NB13-0201

Subject: 2007 Edition, Part 3, Supplement 2, S2.13.10.1 – Weld Buildup of Wastage and Grooving in Stayed Areas

Proposal: Update text to clarify additional requirements, fix 2 typo's and removes a reference that is incorrect.

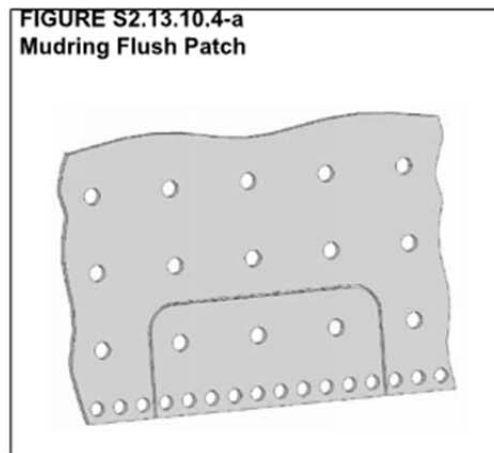
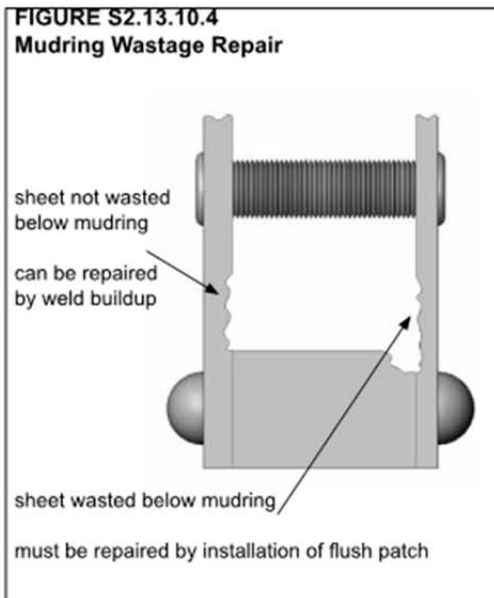
Explanation: Clarify the 60% minimum required thickness and make the description the same in all area's that figure S.2.13.9.1 reference.

1. Change text in b) to include the area exceeding 3 sq. in. (1,950 sq. mm).” Text would state “For mudrings of the locomotive style (See NBIC Part 3, Figure S2.13.10.4), weld buildup shall not be used if the affected section of plate has wasted below 60% of the minimum required thickness per Part 2, Supplement 2 in an area exceeding 3 sq. in. (1,950 sq. mm). (See NBIC Part 3, Figure S2.13.9.1) Repair by weld buildup cannot be used if the wastage extends below the waterside surface of the mudring or if the strength of the structure will be impaired. If extensive welding is required, the affected area shall be removed and replaced with a flush patch.”
2. Change text in c) to state “Wasted sections that have wasted below 60% of the minimum required thickness and have an area exceeding 3 sq. in. (1,950 sq. mm) shall be repaired by installing a flush patch using full penetration welds.”

- b) For mudrings of the locomotive style (See NBIC Part 3, Figure S2.13.10.4), weld buildup shall not be used if the affected section of plate has wasted below 60% of the minimum required thickness per Part 2, Supplement 2 in an area exceeding 3 sq. in. (1,950 sq. mm). (See NBIC Part 3, Figure S2.13.9.1) Repair by weld buildup cannot be used if the wastage extends below the waterside surface of the mudring or if the strength of the structure will be impaired. If extensive welding is required, the affected area shall be removed and replaced with a flush patch.”
- c) Wasted sections that have wasted below 60% of the minimum required thickness and have an area exceeding 3 sq. in. (1,950 sq. mm) shall be repaired by installing a flush patch using full penetration welds.

FIGURE S2.13.14.2
Repair of Handhole Opening

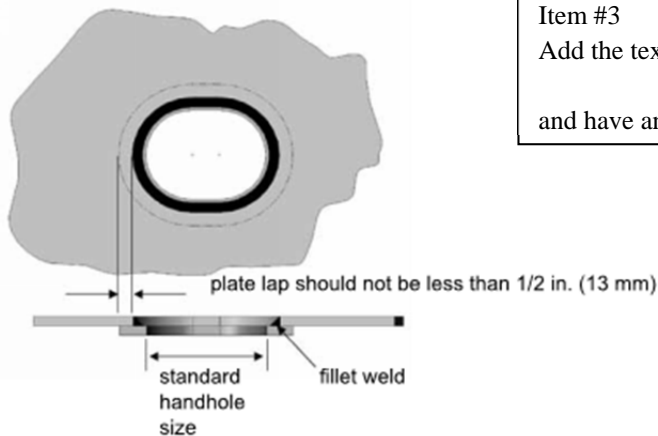
1. Add “in an area exceeding 3 sq. in. (1,950 sq. mm).” to a)
2. Move Text “Weld buildup of wasted areas shall not exceed 100 sq. in. (65,000 sq. mm).” to item d) to match other area's of the NBIC repair section.
3. Add “and have an area exceeding 3 sq. in. (1,950 sq. mm)” to c)

- b) Weld buildup is to replace material that has been lost due to wastage and grooving, and is not to replace thickness on the opposite side of the sheet. Weld buildup must be applied to the side of the sheet that is wasted or grooved.
- c) Wasted sections that have wasted below 60% of the minimum required thickness shall be repaired by installing a flush patch using full penetration welds or by the installation of a ring on the inside (pressure side) of the sheet. (See NBIC Part 3, Figure S2.13.14.2).

- a) Weld buildup shall not be used if the affected section of plate has wasted below 60% of the minimum required thickness per Part 2, Supplement 2 in an area exceeding 3 sq. in. (1,950 sq. mm). (See NBIC Part 3, Figure S2.13.9.1)
- b) Weld buildup is to replace material that has been lost due to wastage and grooving, and is not to replace thickness on the opposite side of the sheet. Weld buildup must be applied to the side of the sheet that is wasted or grooved.
- c) Wasted sections that have wasted below 60% of the minimum required thickness and have an area exceeding 3 sq. in. (1,950 sq. mm), shall be repaired by installing a flush patch using full penetration welds.
- d) Weld buildup of wasted areas shall not exceed 100 sq. in. (65,000 sq. mm).
